Service Info

Tensioning arm 534 0325 10

Improved markings

Part no.: 534 0325 10

Image 1: Tensioning arm 534 0325 10 – Left, old version with fixing screws M8x40. Right, new version with fixing screws M8x30.

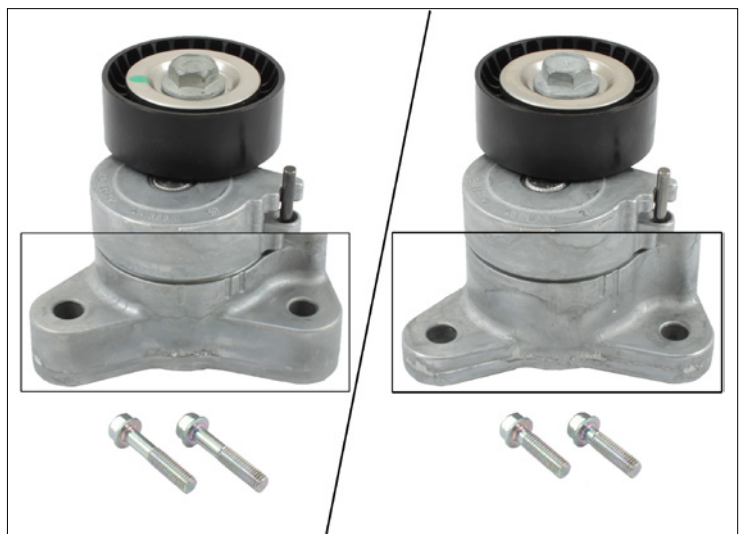
As part of our continuous efforts to improve our products, changes have been made to the tensioning arm 534 0325 10.

Please note that the fixing screws supplied are shorter to match the thinner mounting flange (image 1).
